**Subject: Request for Modification to Individual Section 404 Permit, Individual Water Quality Certification and, CAMA Major Development Permit** the proposed widening of US 158 from Murfreesboro Bypass to US 13 West of Winton, Hertford County. TIP R-2583; Debit \$570 from WBS 35489.1.1

**References:** R-2583 Section 404 Individual Permit issued July 18, 2012 (USAID SAW-2002-11081);  
R-2583 Section 401 Water Quality Certification issued January 19, 2012 (DWQ No. 20111075);  
R-2583 CAMA Major Development Permit issued June 7, 2012 (CAMA permit No. 63-12);

The purpose of this letter is to submit a modification request for the permits listed above. Revised permit drawings and impact summary sheet are included with this modification request.

**SITE 1**

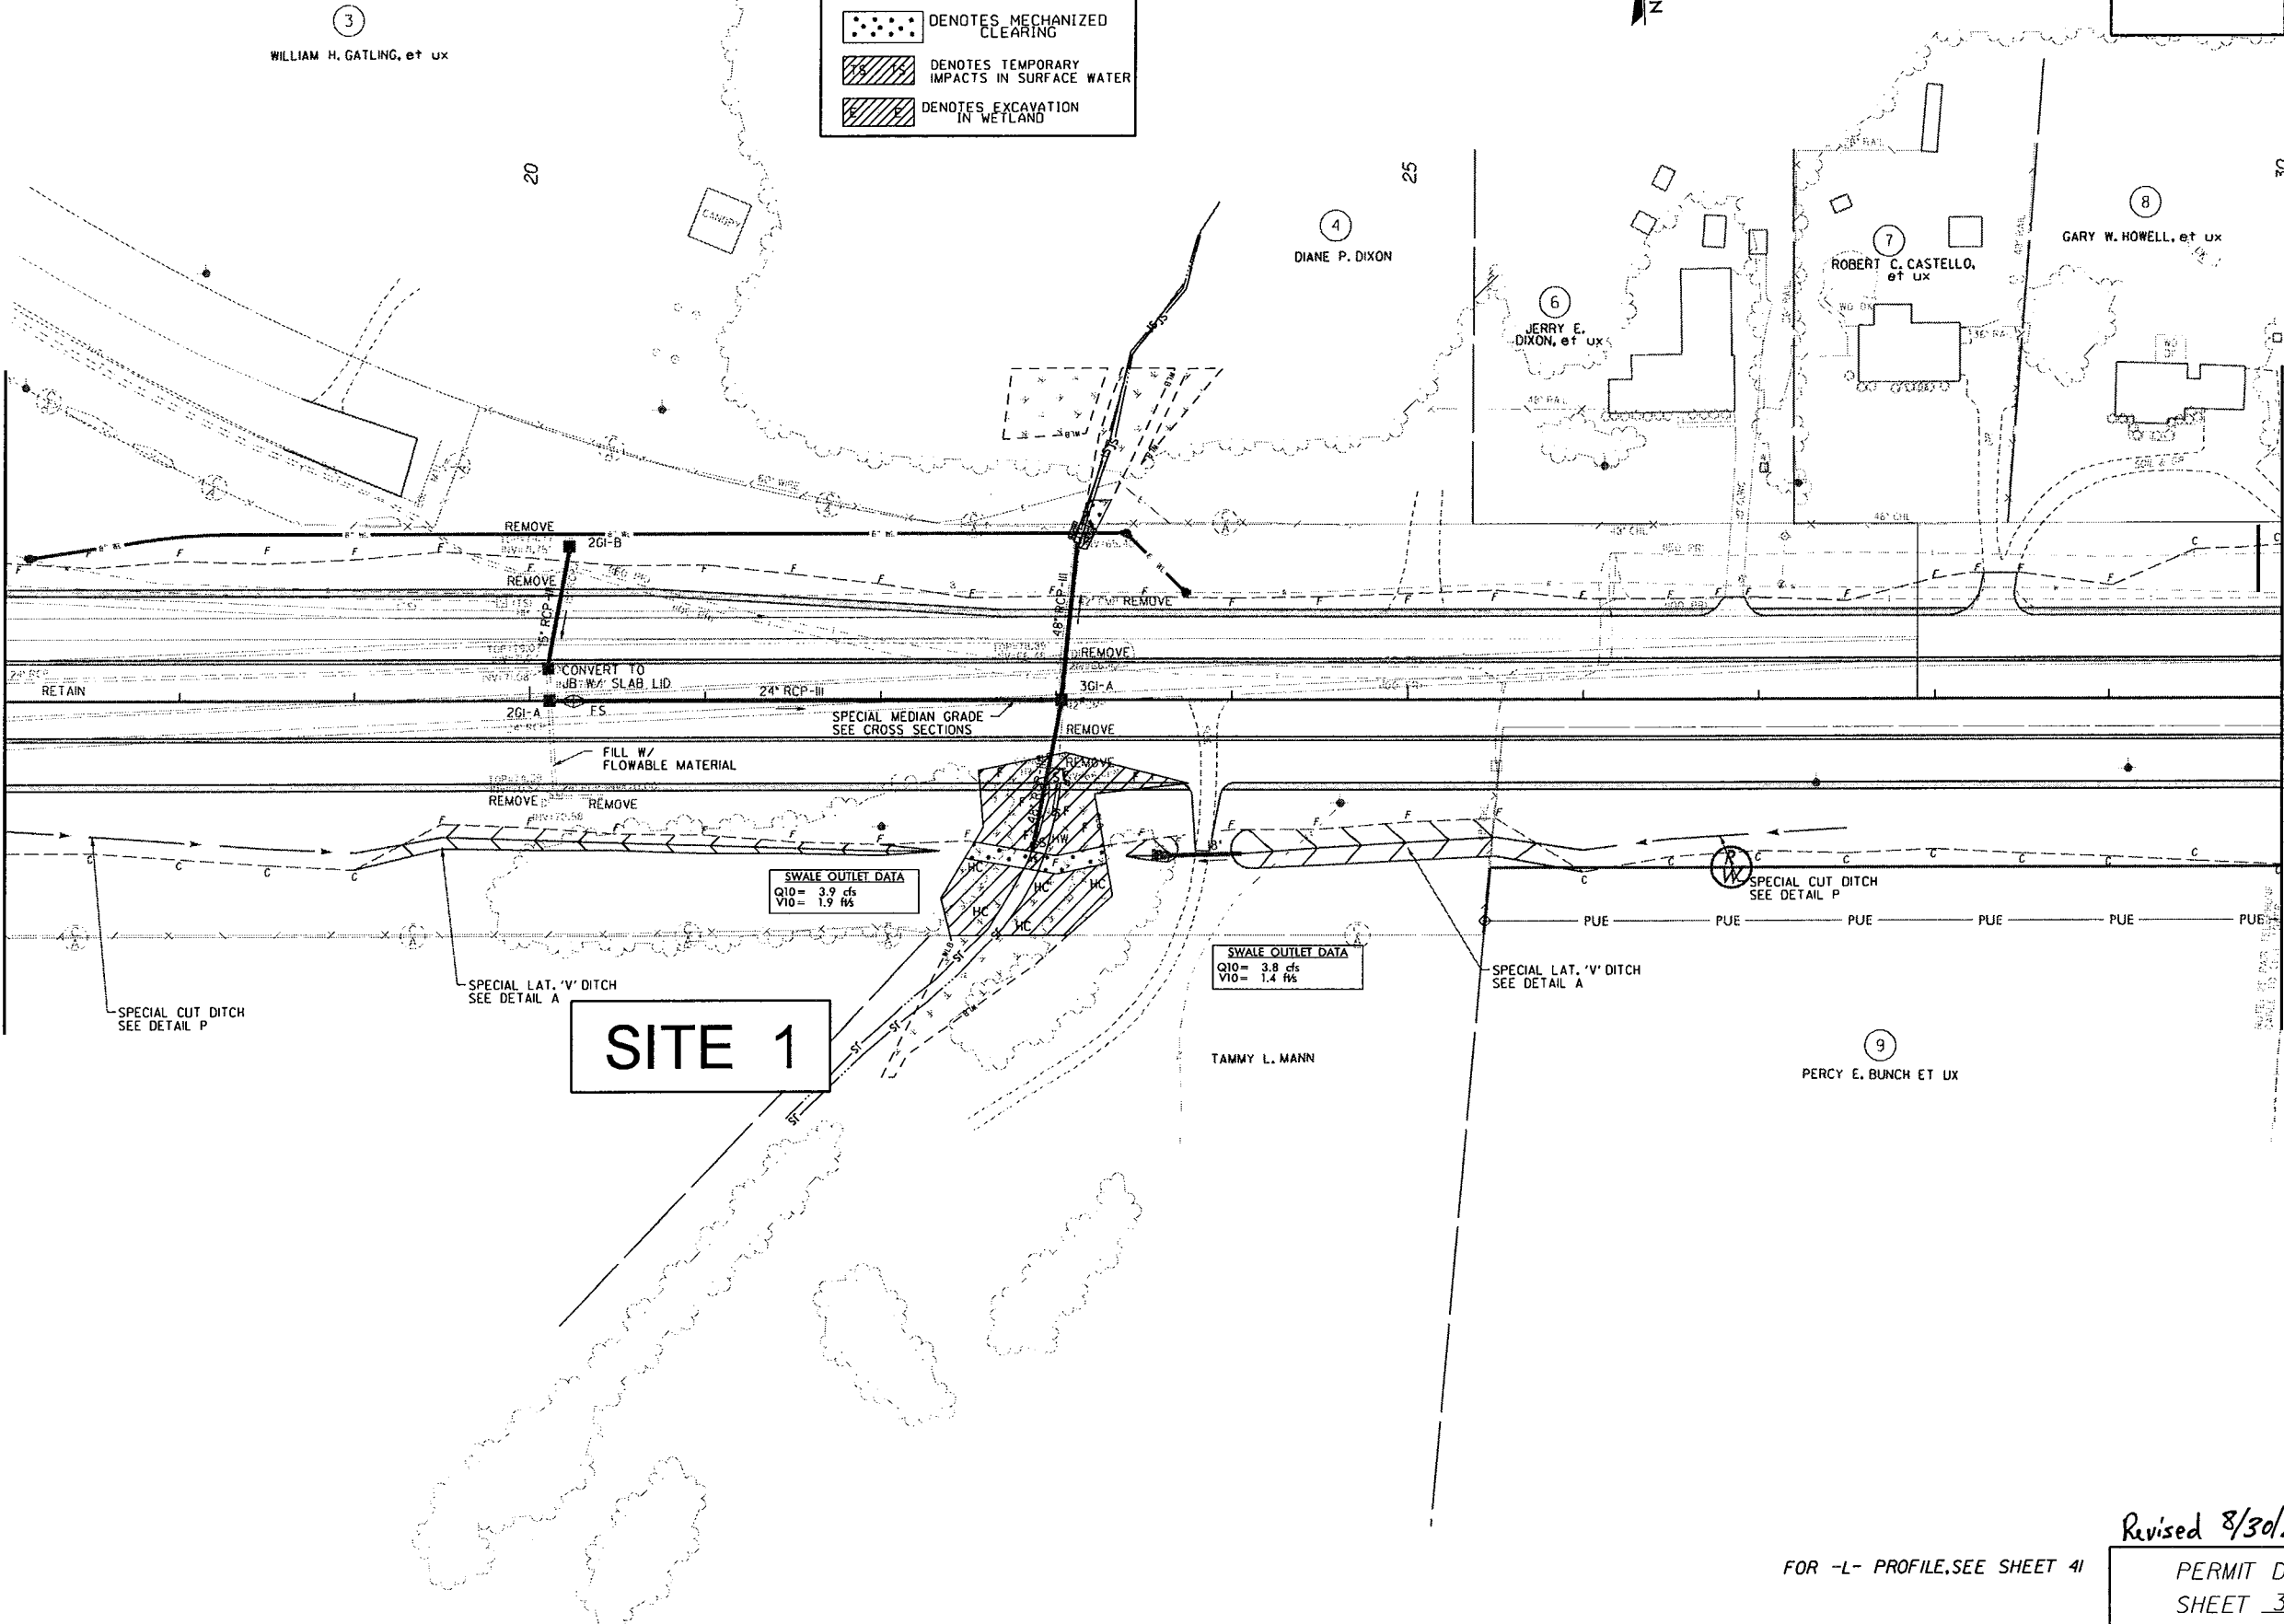
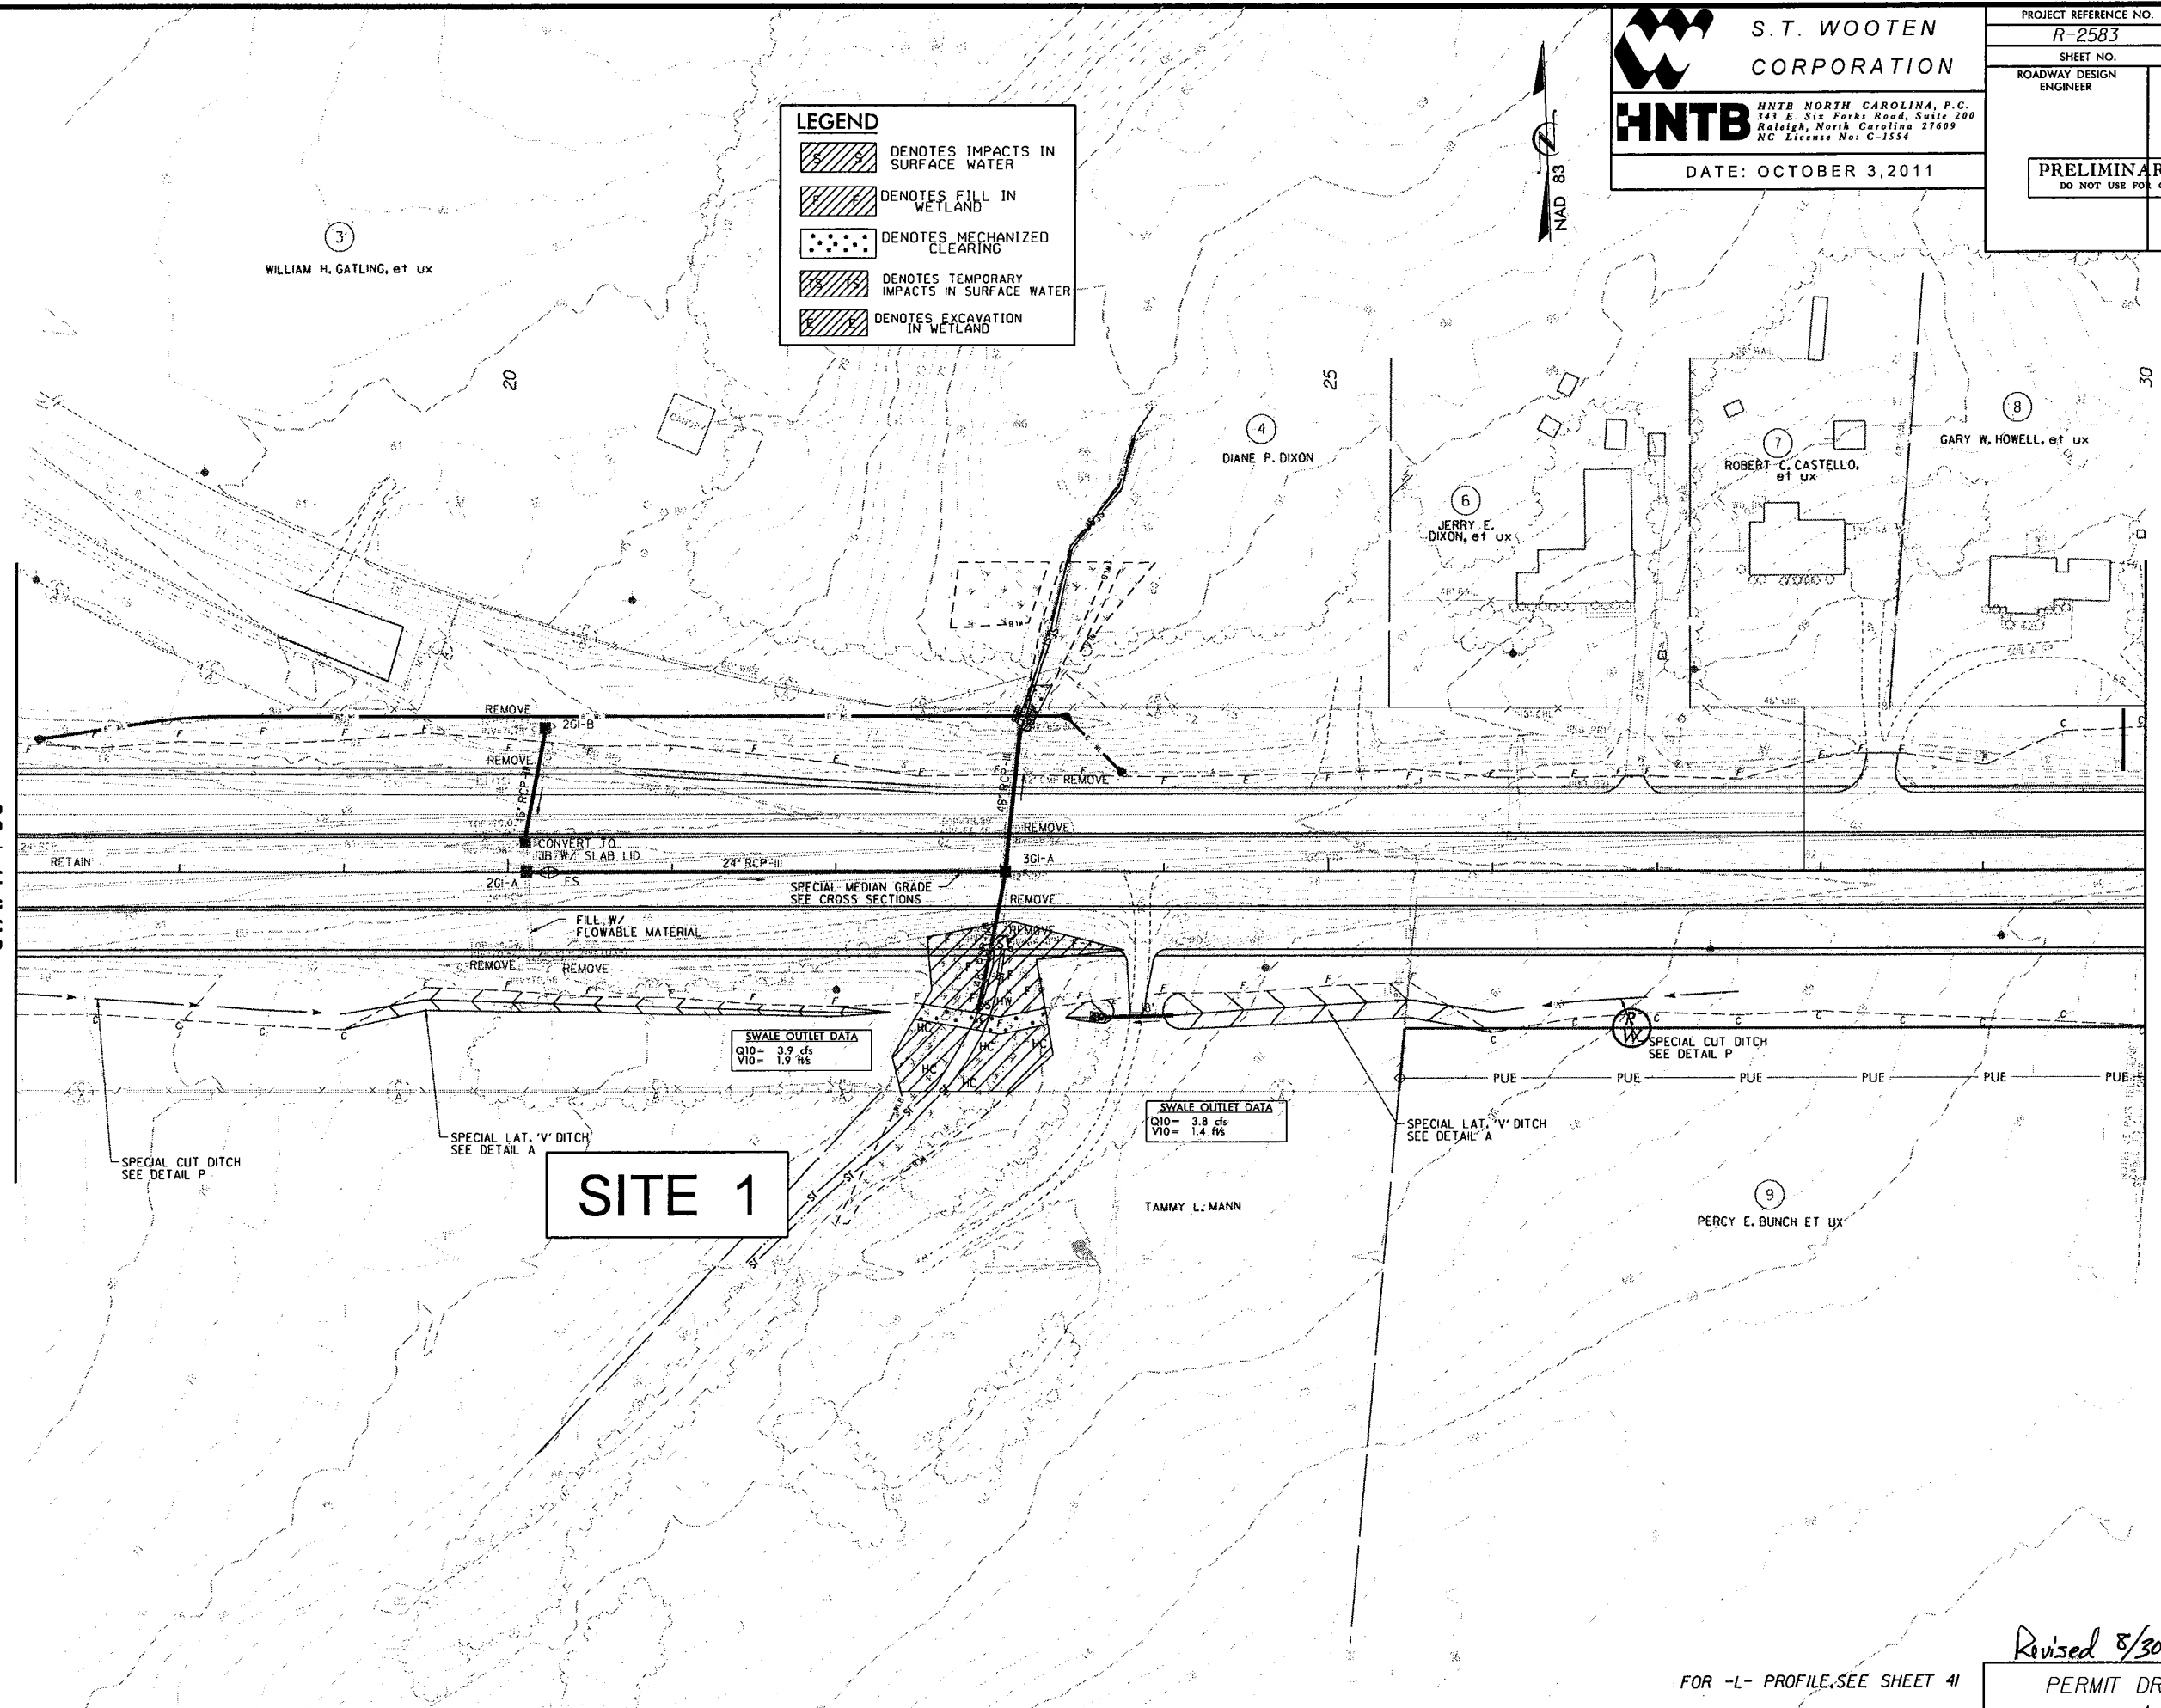
Due to a realignment of the water line, temporary stream impacts have decreased by 10 feet resulting in a total temporary stream impacts of 212 linear feet. Additionally, hand clearing in wetlands increased by 0.07 acre due to the installation of the power line south of 158. Total hand clearing for the project is now 0.89 acre. Proposed permanent impacts to wetlands and streams have not changed.
